This addendum forms a part of the Contract Documents and modifies the original Documents dated **December 12, 2025** as noted below. Acknowledge receipt of this addendum in the space provided on the Official Bid Form. Failure to do so may subject the Bidder to disqualification.

ADDENDUM 2

project:  
**AMITY SCHOOL DISTRICT DISTRICT OFFICE BUILDING**  
 503 OAK AVENUE  
 AMITY, OR 97101

SURFACING PLAN	
sheet:	<b>C4.0</b>
of:

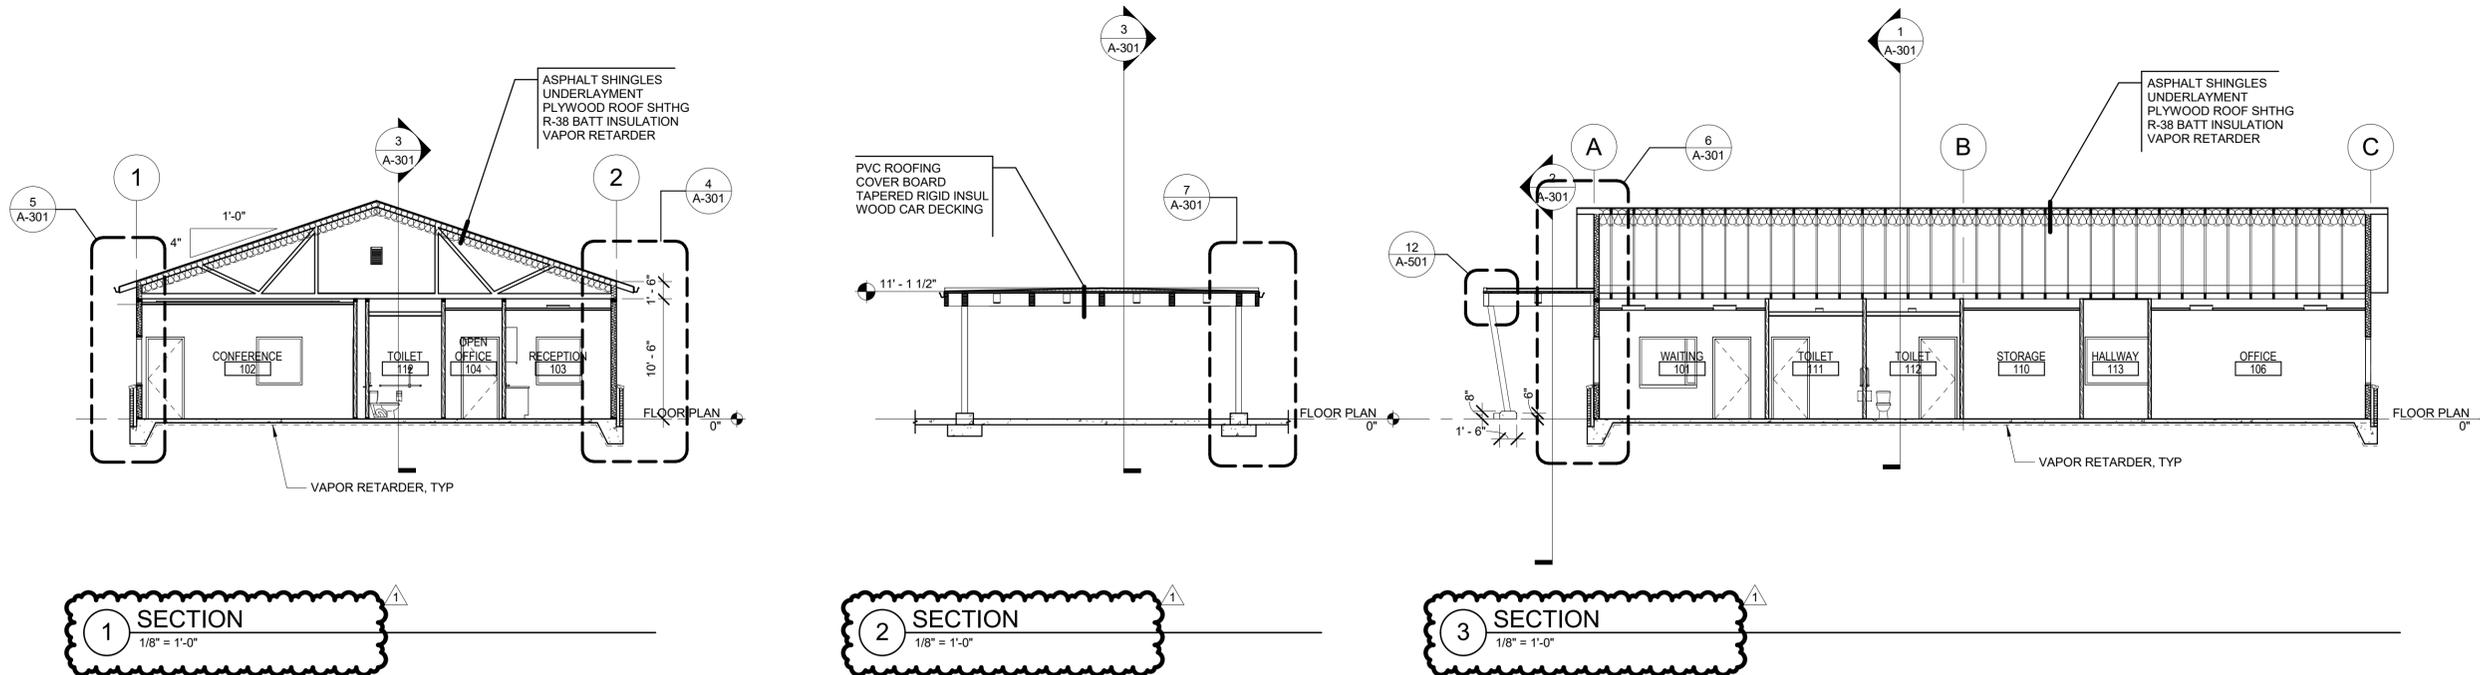
**Question:** I need clarification on C-4.0 surfacing plan. The new AC paving seems short of what is needed for the parking lot. The shaded paving is incomplete for the scope.

**Question:** Please confirm the future deployment will require additional asphalt removal and replacement to tie to the current drive.

**Question:** Please confirm the limits of the concrete curb to be installed.

**Question:** Please confirm the existing sidewalk is to remain.

**Answer:** Refer to markup drawing sheet C4.0 for surfacing clarifications.

**Answer:** Refer to markup drawing sheet C4.0 for surfacing clarifications.

**Answer:** Refer to markup drawing sheet C4.0 for surfacing clarifications.

**Answer:** Refer to markup drawing sheet C4.0 for surfacing clarifications.

Disregard **original** – C4.0 – Surfacing Plan and replace with the **ENCLOSED C4.0 – Surfacing Plan** in its entirety.

1. Contains markup with updated surfacing notes and extents.

**BUILDING SECTIONS**

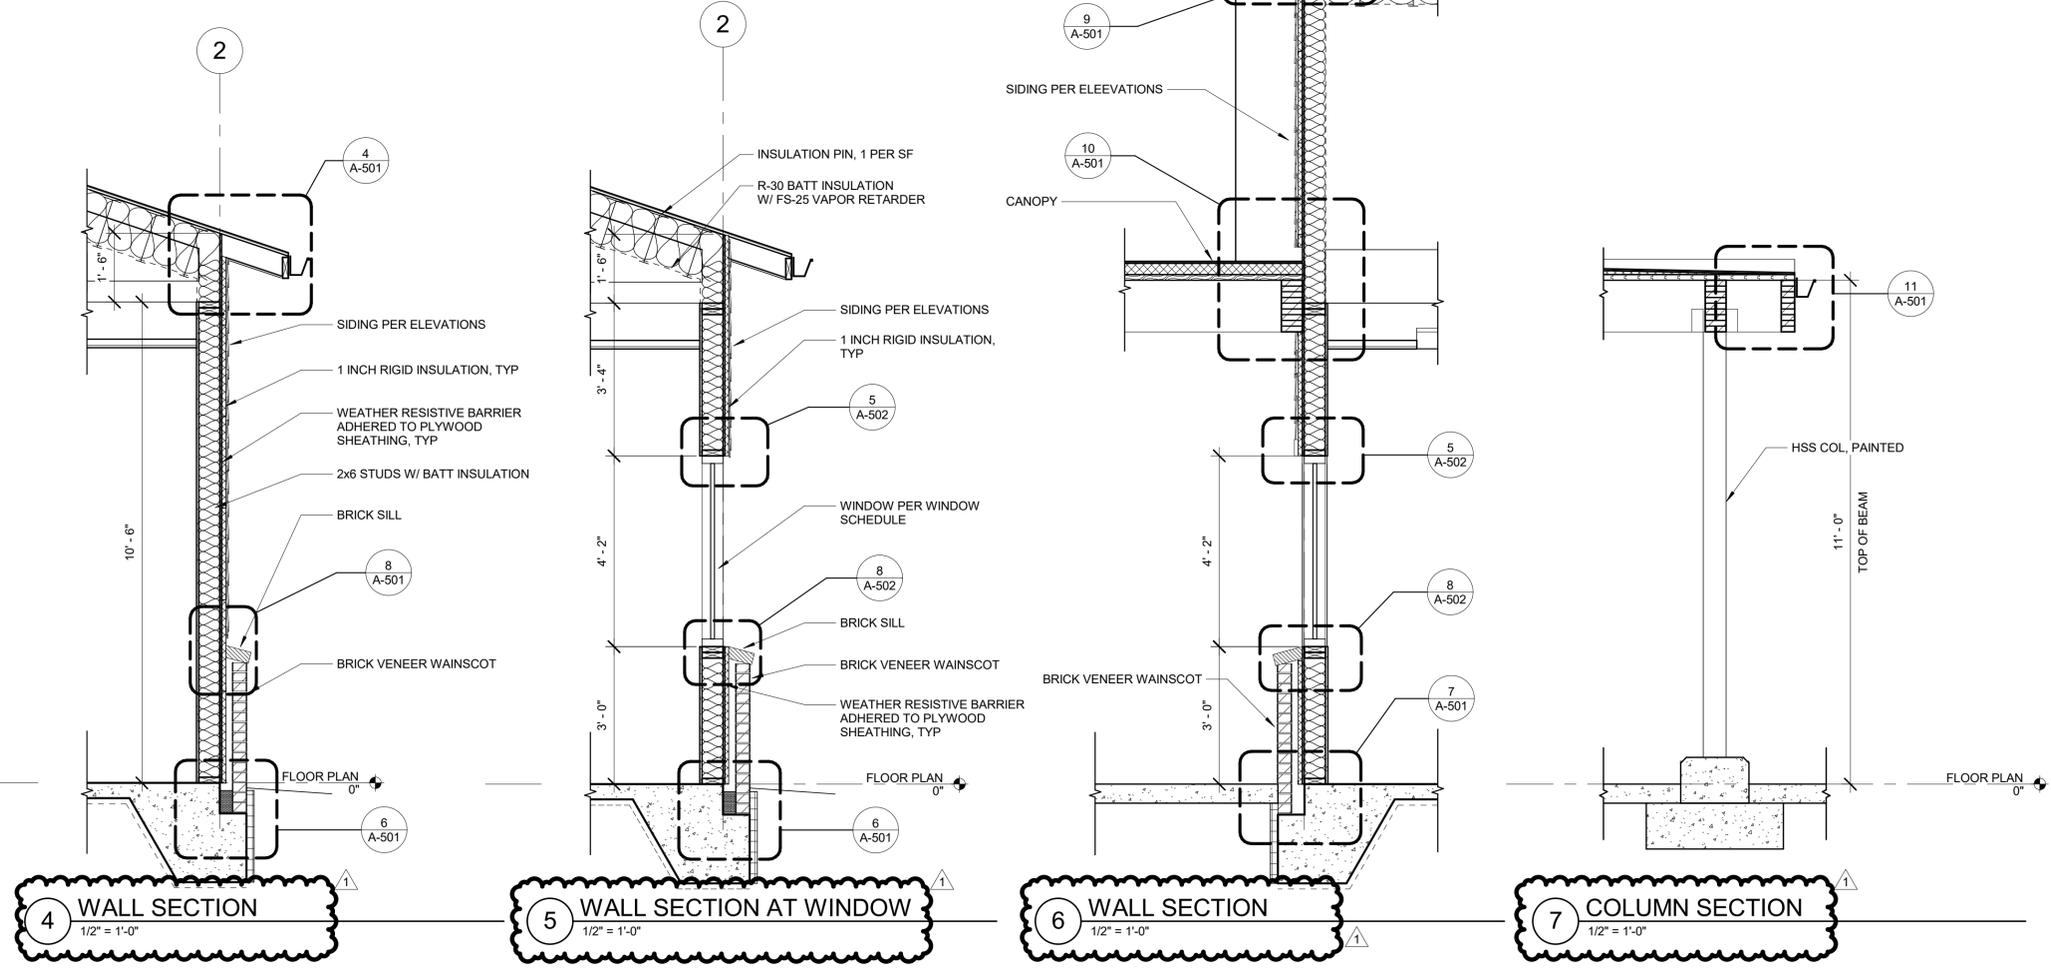
**Question:** What is the R-Value of the roof insulation and is it to be installed tight against the roof deck or do we need to leave an air space between the insulation and the roof deck?

**Question:** The insulation required would be too thick (14") to suspend and then would require flame spread paper along with making the attic a conditioned space, I think. But it seems we are unable to install batt insulation per spec and drawing on roof line. Detail 5 A 3.01 shows insulation in upper truss cord. Unable to get R value insulation in that area. Please advise.

**Answer:** Roof insulation is R-38, refer to revised drawings A-301, A-501 and revised specification section 07 21 00 Thermal Insulation for additional information.

**Answer:** R-38 insulation is 12" thick. Insulation in attic to be pin stuck, refer to revised drawings A-301, A-501 and revised specification section 07 21 00 Thermal Insulation for additional information.

Disregard **original** – A301 – BUILDING SECTIONS and replace with the **ENCLOSED A301 – BUILDING SECTIONS** in its entirety.

1. Added notes to various details
